ADDENDUM #7

Snowden Admin Building Mechanical Upgrades Project No. ANC-C-23-0001

Date: December 2, 2022

C BOILER SECTION - SOUTH
M301 Scale: 1/2" = 1'-0"

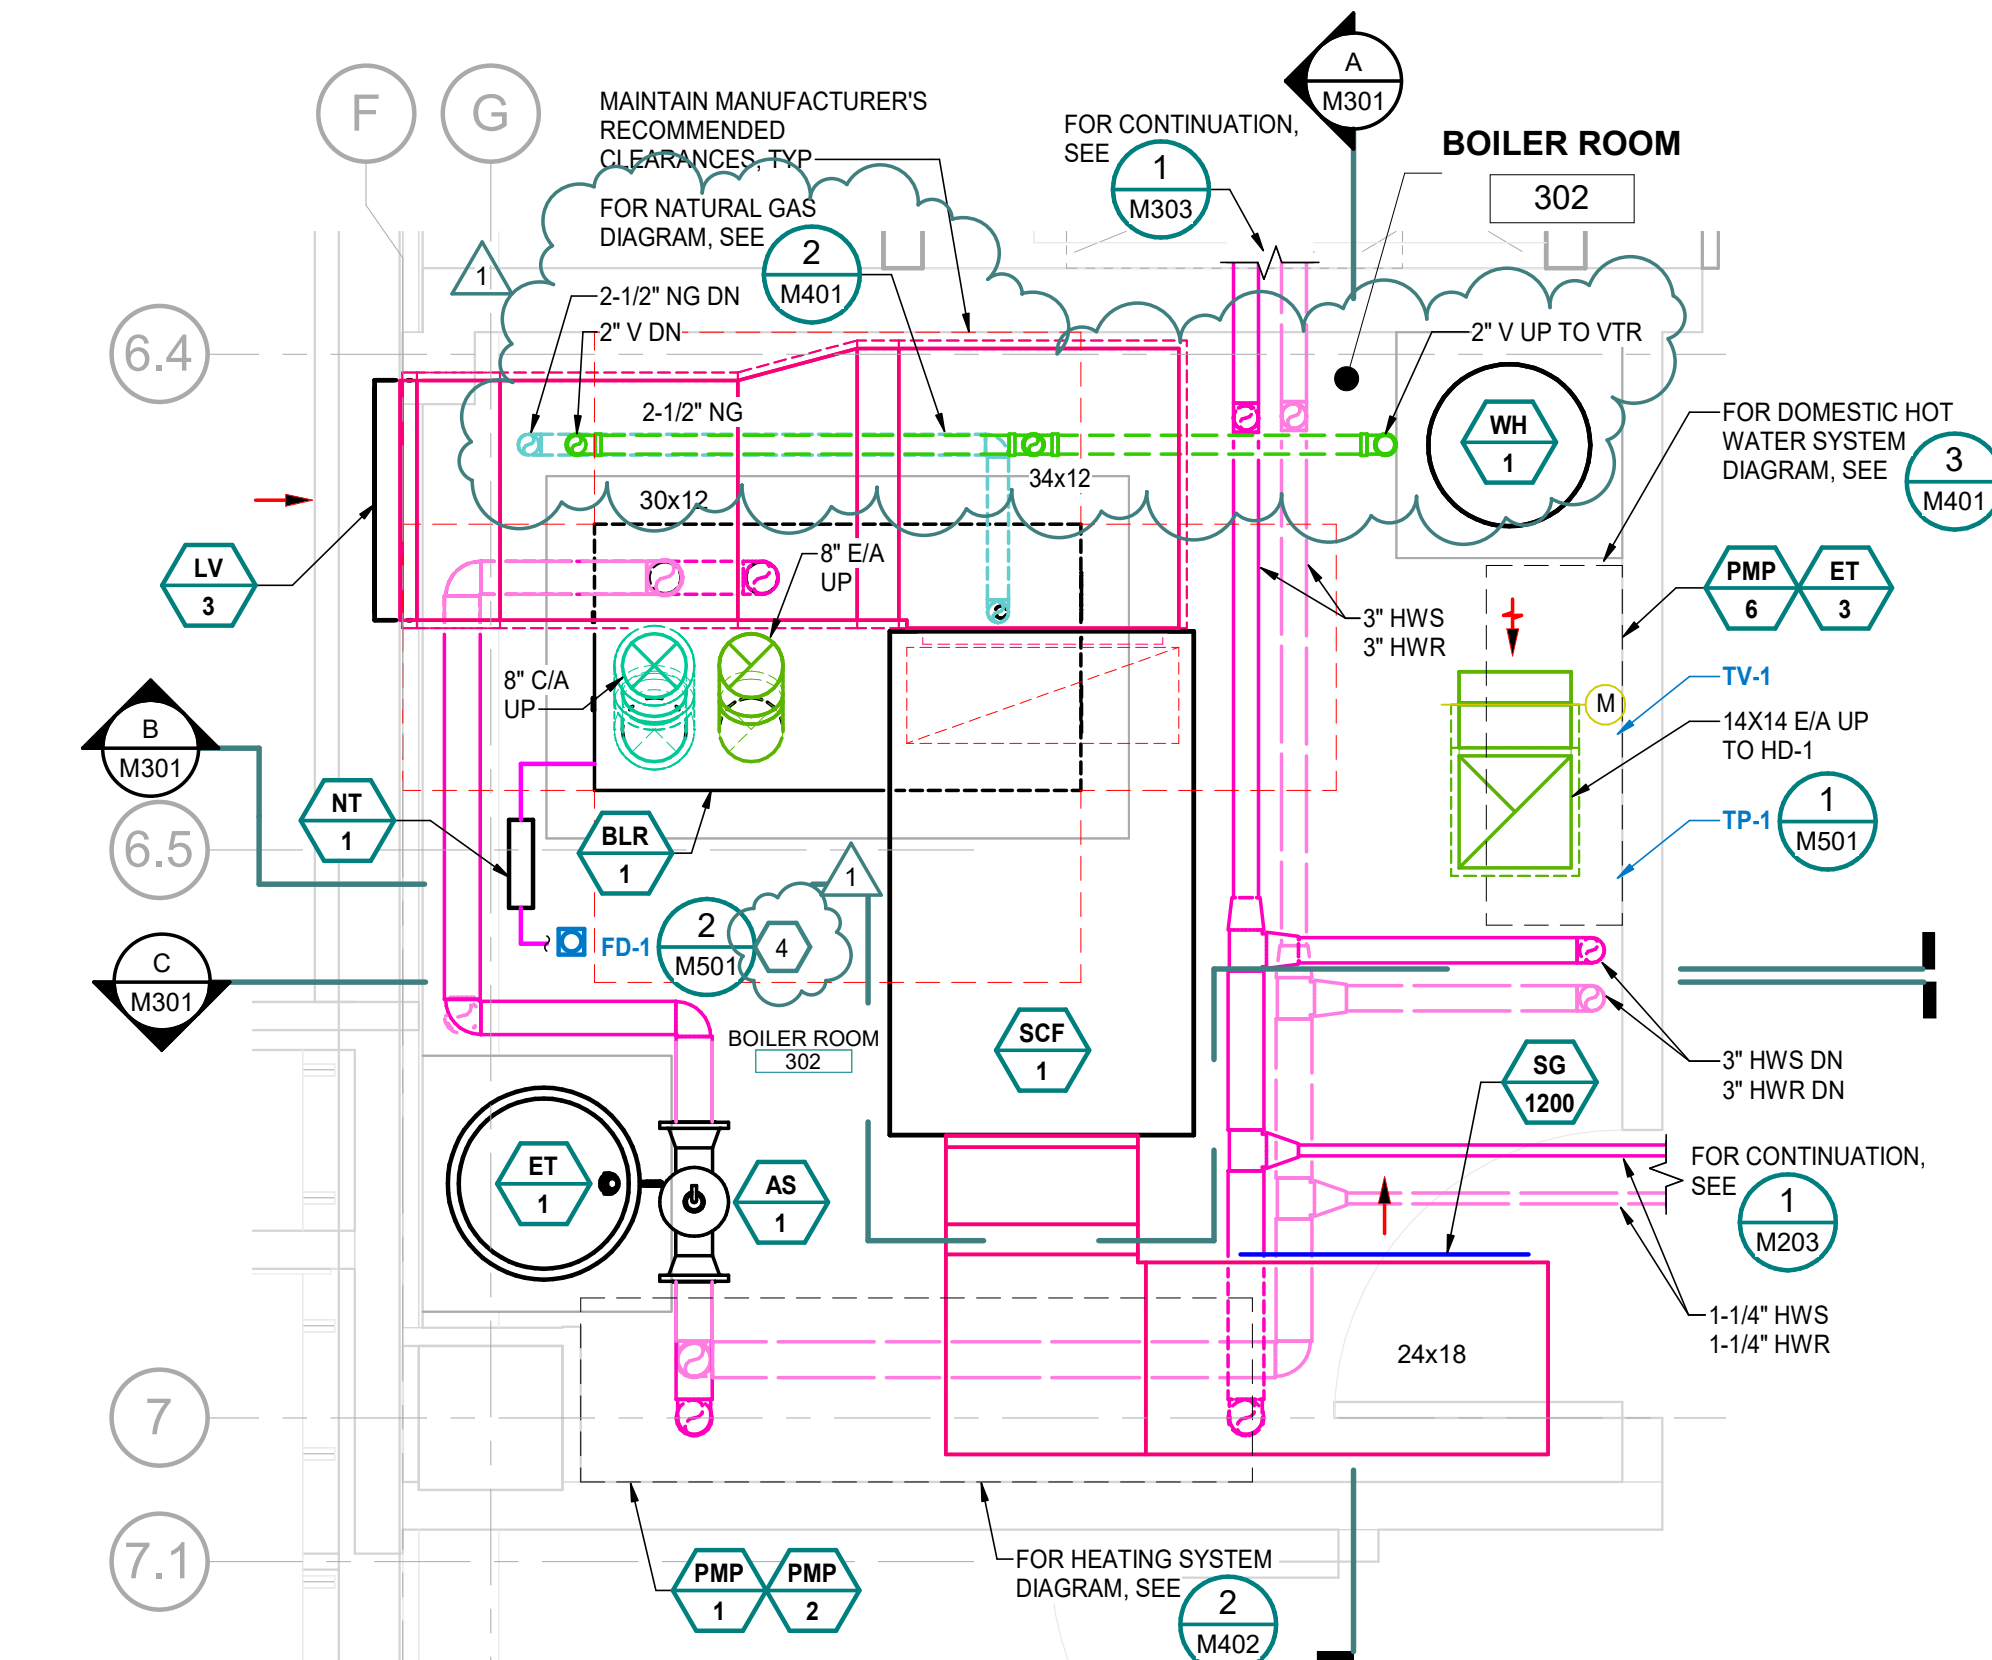
- a. ADD hydronic system isolation valves as indicated on reissued drawings M201 and M202.
- b. DEMOLISH existing floor drain and PROVIDE new floor drain, FD-1, as indicated on reissued drawings M108 and M303.
- c. ADD sheet note #4, vent piping, and VTR, for new floor drain, FD-1, connection clarification as indicated on reissued drawing M301.

1. Drawing M-108 shows an existing floor drain that is to remain. Detail 1 on M-301 shows a FD-1 floor drain being installed in the same location. Is there a new drain required as shown on M-301 or does the existing drain remain as shown on M108?

2. Detail 1 on M-301 shows a new FD-1 floor drain being installed. There is nothing shown clarifying where this drain is to be connected. Please advise.

AMC Response: The fan room floor drain is to be demolished and replaced, see reissued drawings M108 and M303. The new boiler room on M301 will have a new floor drain as shown.

AMC Response: See reissued drawing M301 for new floor drain, FD-1, connection clarification.

1. MINIMUM PIPE SIZE IS 3/4". TERMINAL DEVICE BRANCH PIPE IS 3/4", UNLESS OTHERWISE NOTED.
2. PROVIDE MANUAL HIGH POINT VENTS, LOW POINT DRAINS (WITH CAPPED HOSE CONNECTIONS), AND SLOPE PIPING TO ALLOW FOR COMPLETE DRAINAGE OF THE HYDRONIC SYSTEM.
3. FOR TYPICAL PIPE AND DUCT PENETRATION, SEE DETAIL 1/M506.
4. FIELD ROUTE AND CONNECT FLOOR DRAIN WASTE PIPING TO DWV/E PIPING IN CEILING BELOW. CONNECT P-TRAP TO TRAP PRIMER TP-1 IN BOILER ROOM 302. FIELD ROUTE VENT PIPING IN BOILER ROOM AND PROVIDE NEW VTR, SEE DETAIL 3/M501.

Sheet Title
ENLARGED THIRD
FLOOR FANROOM
PLAN

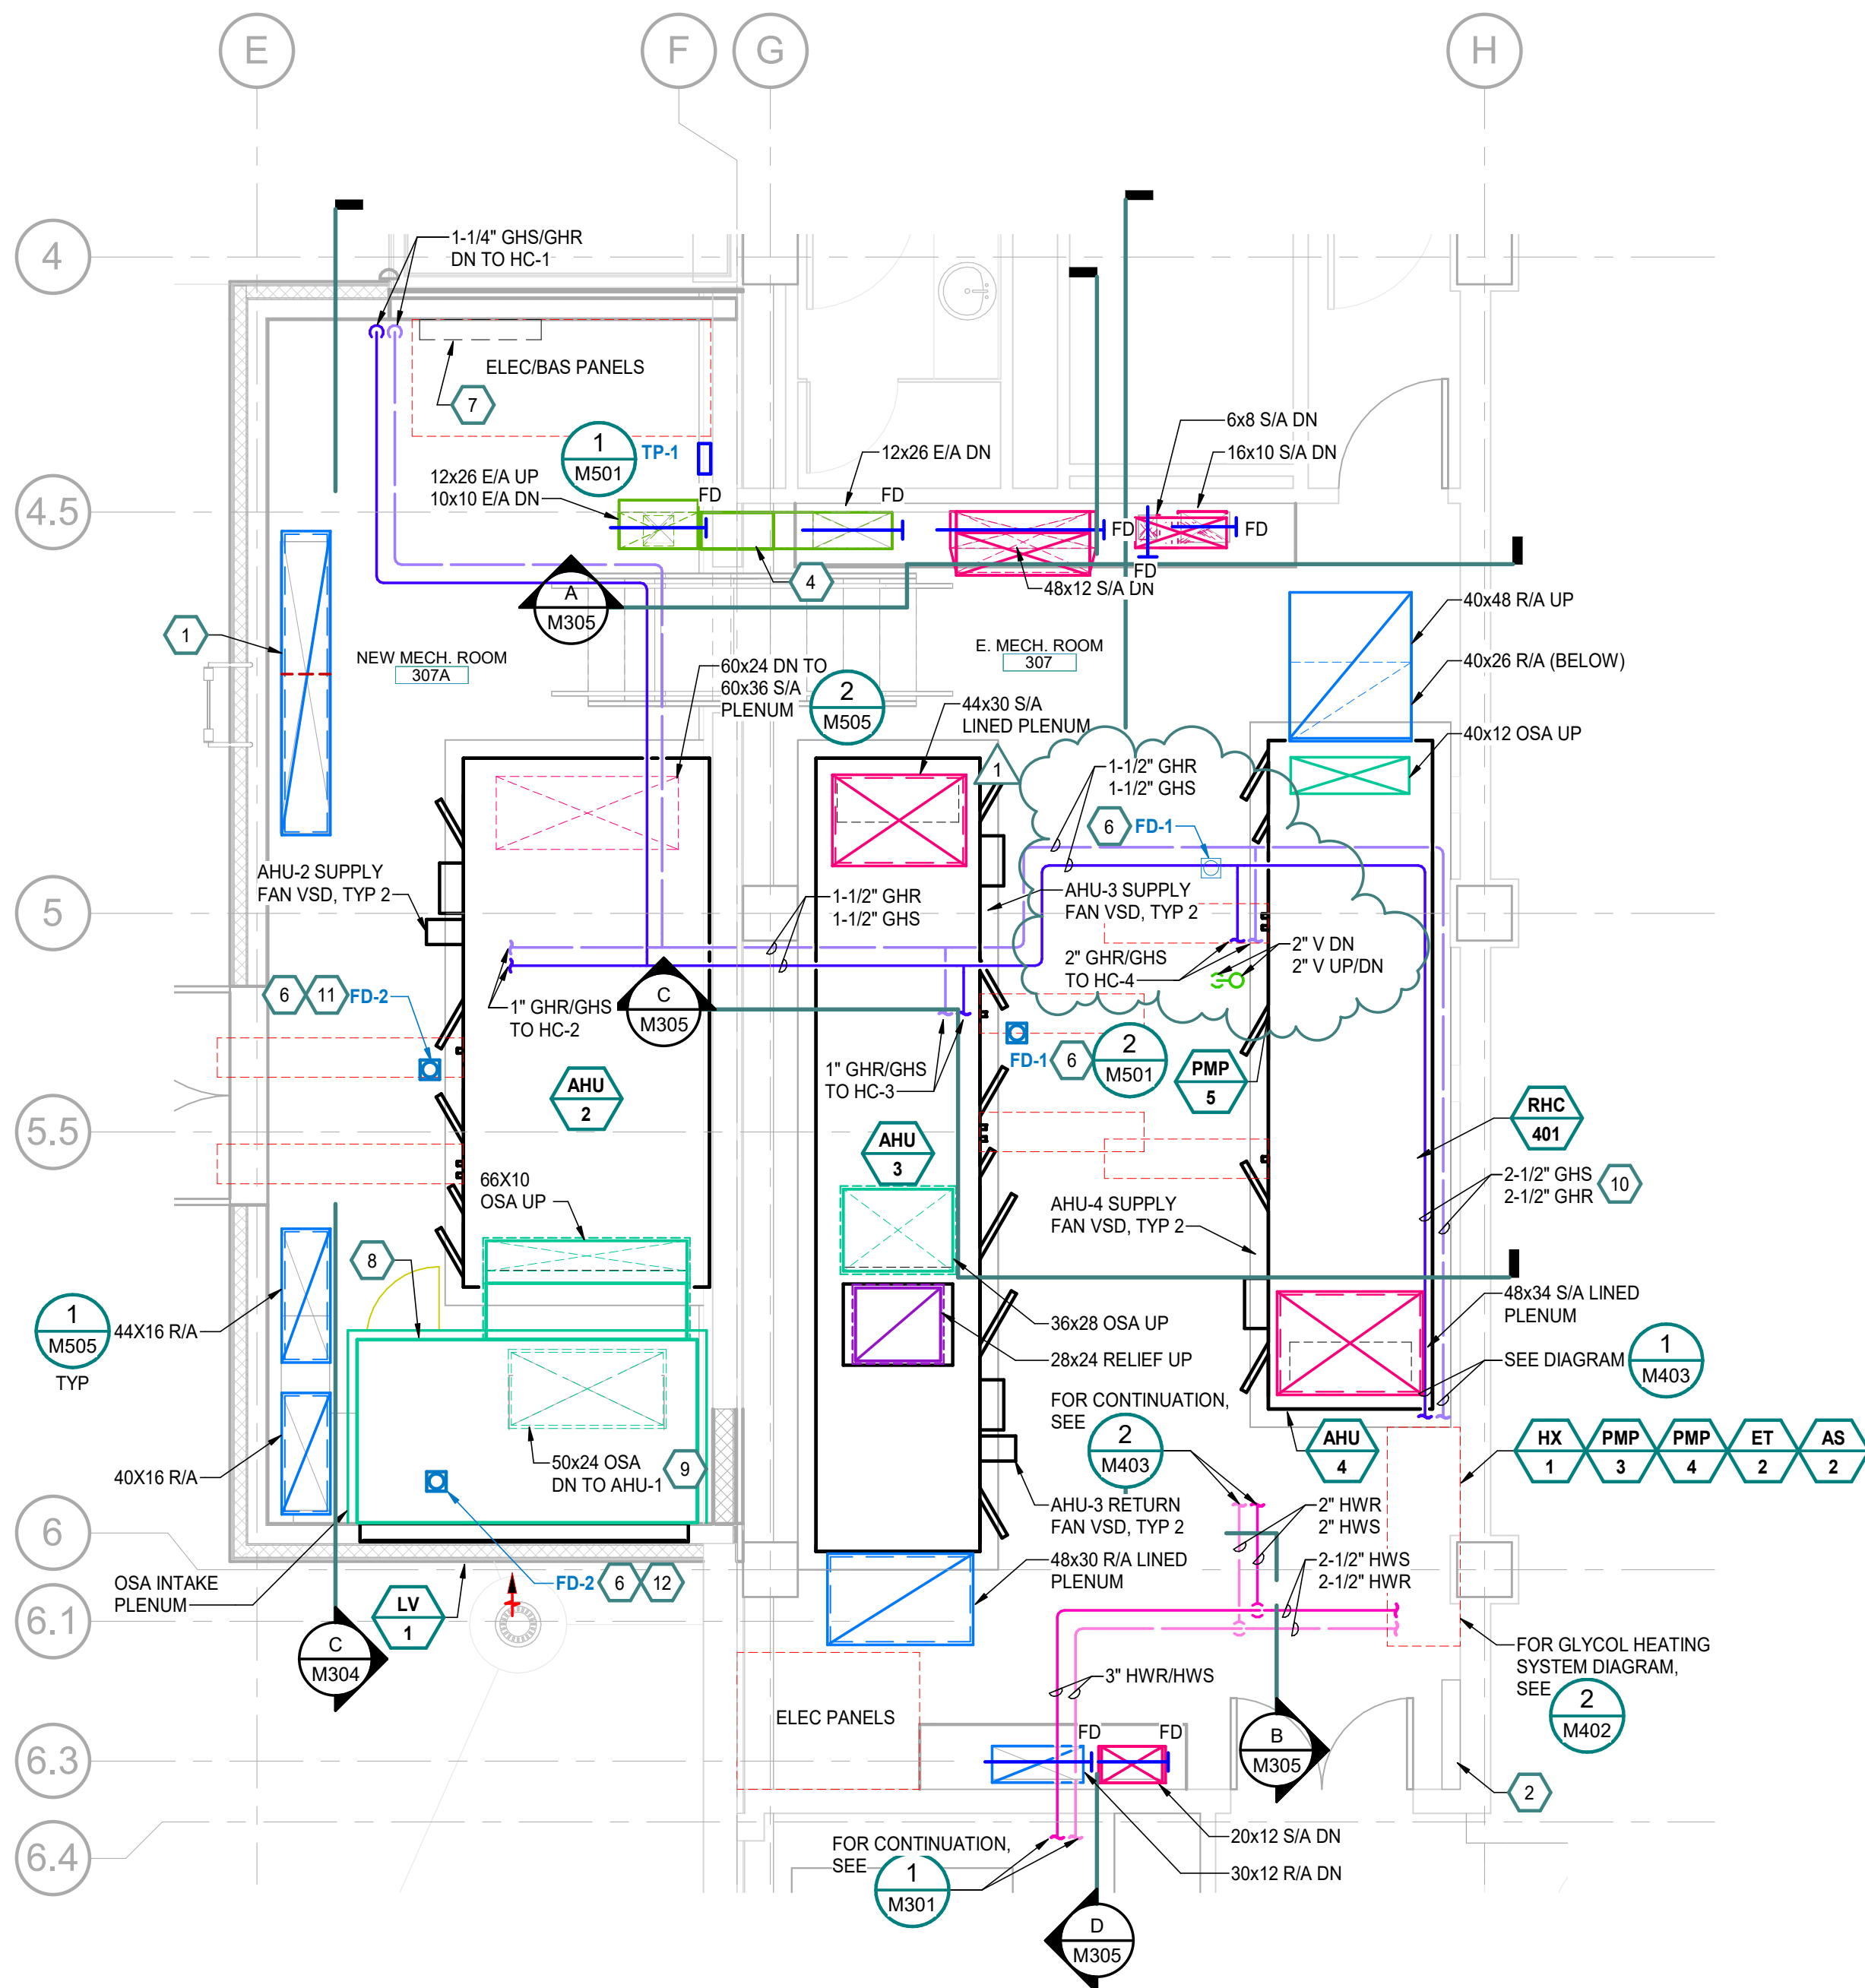
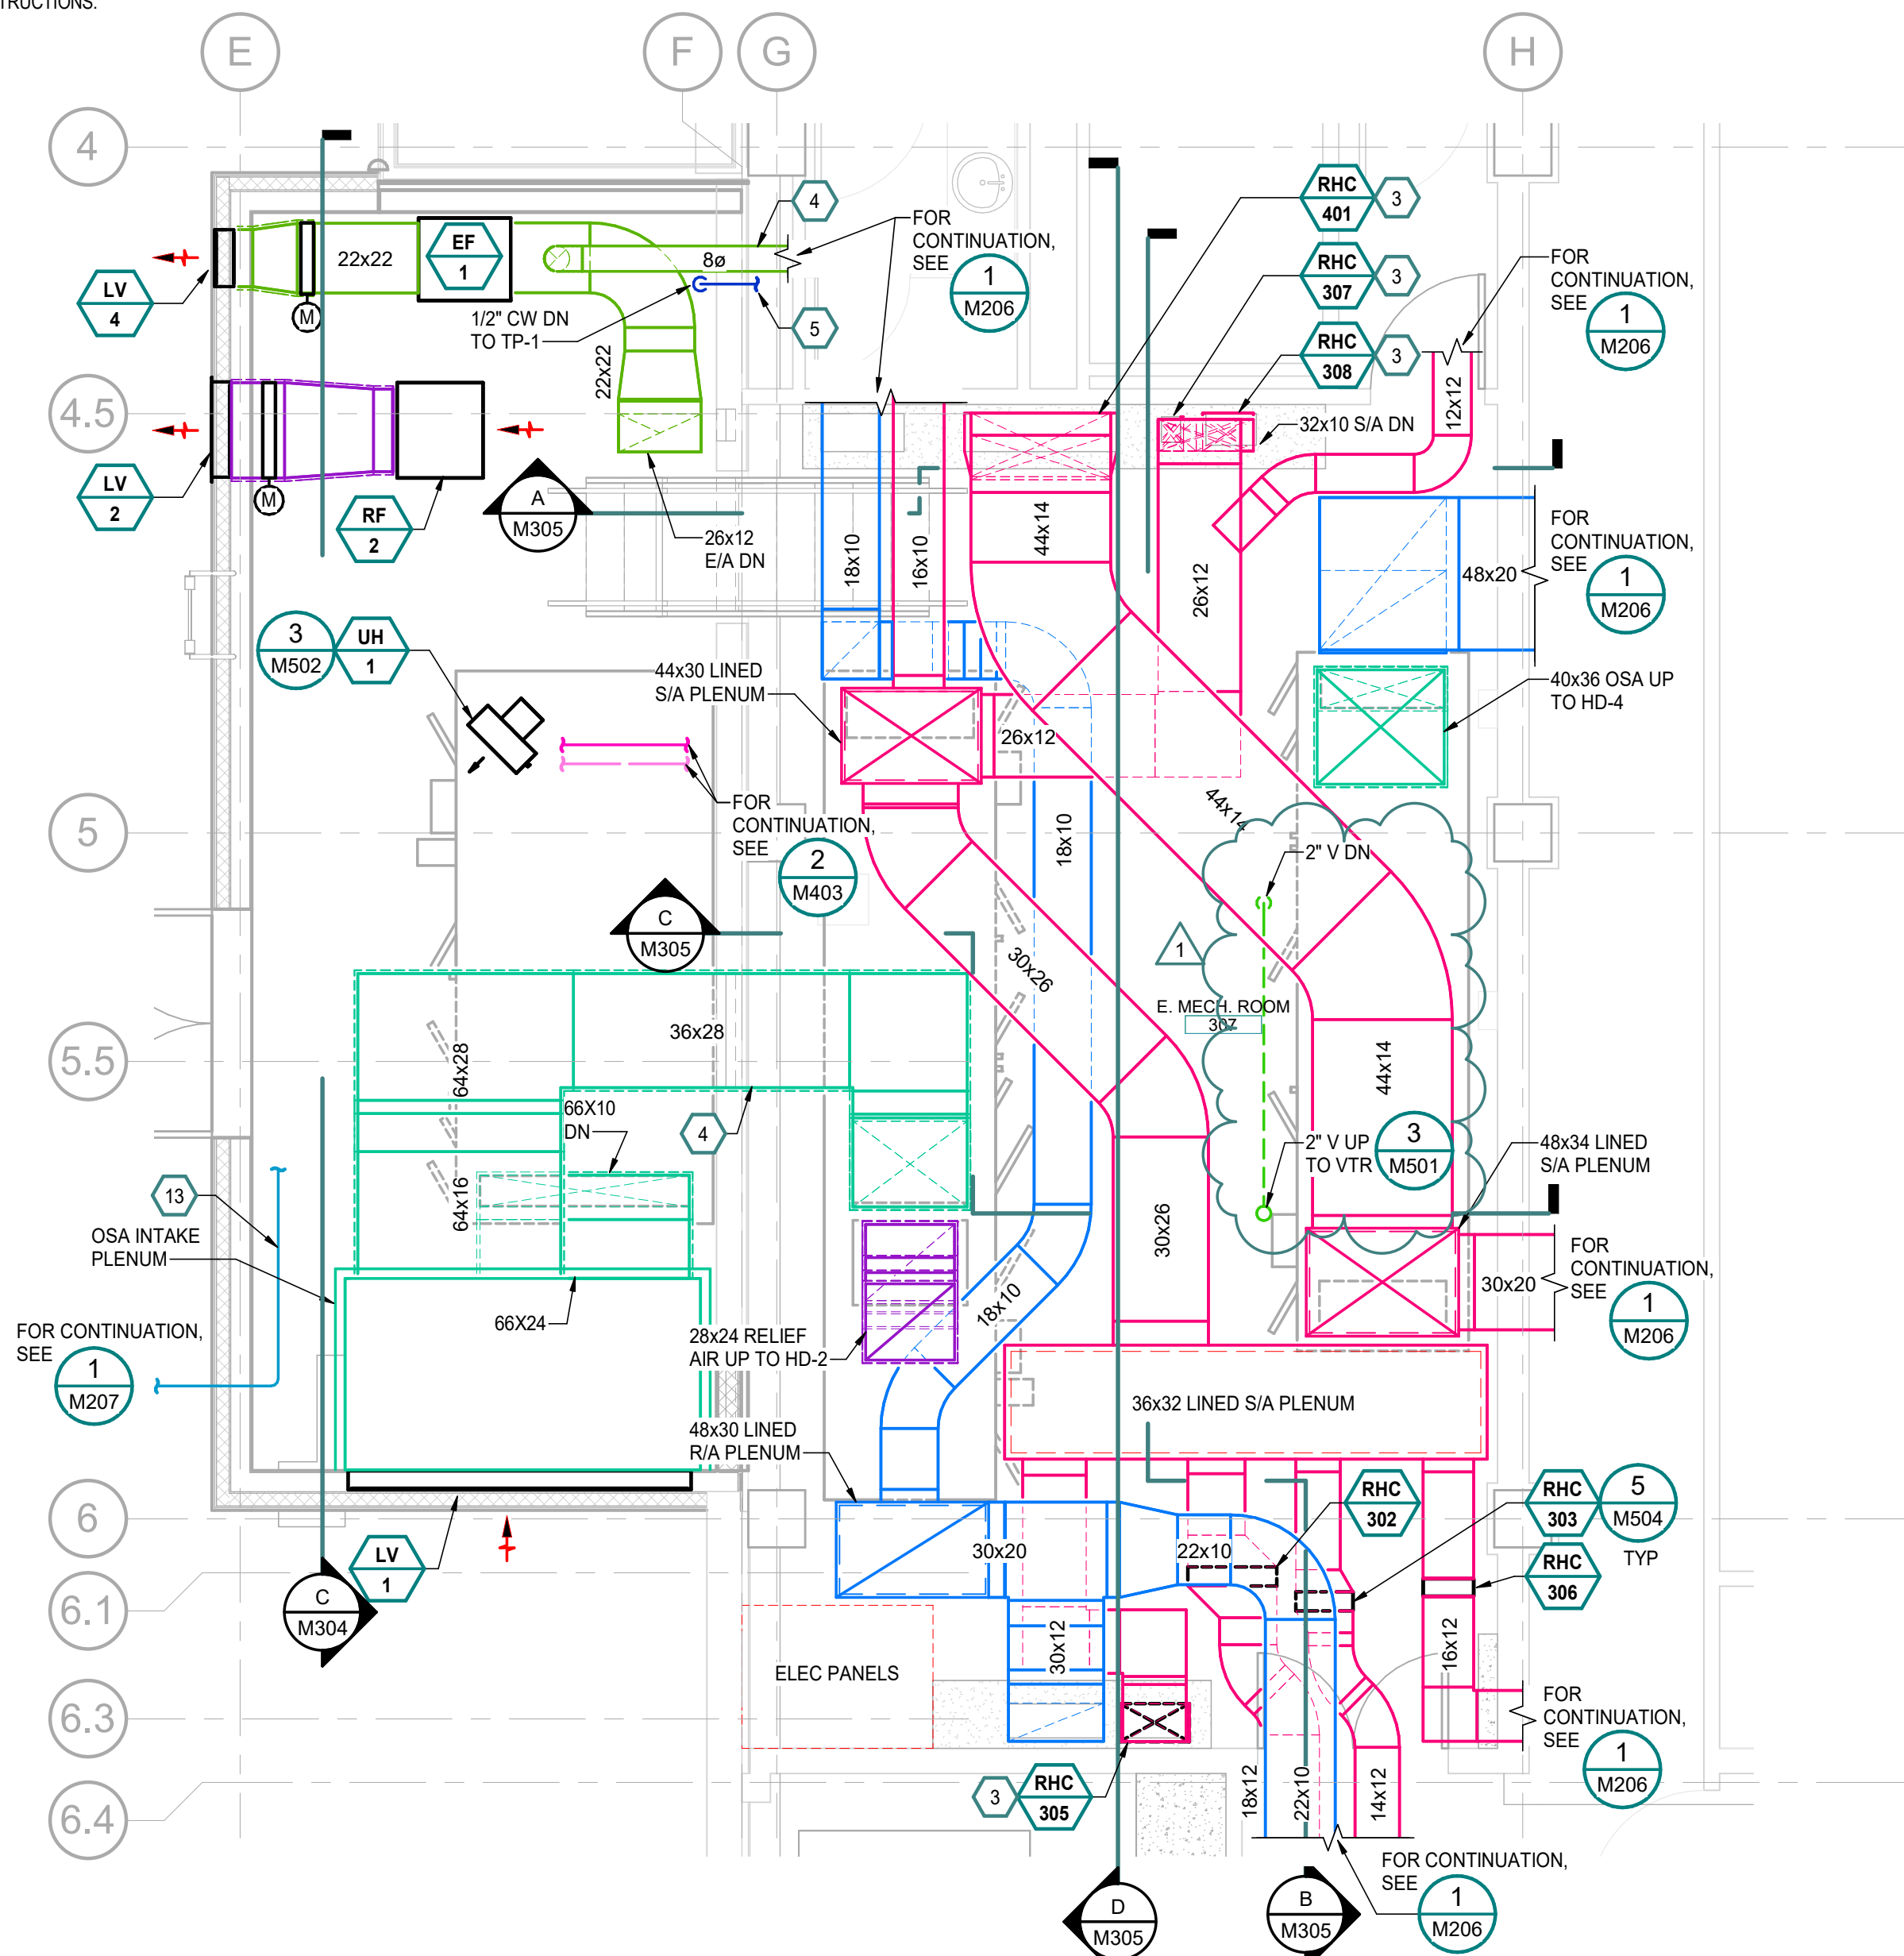
3. In addition to the TP-1 trap primer in the new mechanical room shown on M-301 there are TP-1 trap primers shown in Fan Room 226 on detail 1, Drawing M-302 and Mechanical Room 307, Drawing M-303. Are these new or existing trap primers. If they are new where is the water supply to these to come from?

AMC Response: These are all new trap primers. Fan Room 226 trap primer CW connection is shown on 2/M302 by sheet note #2. Mech Room 307 trap primer CW connection is shown on 2/M303 by sheet note #5. Boiler room 302 trap primer CW connection is shown on diagram 3/M401.
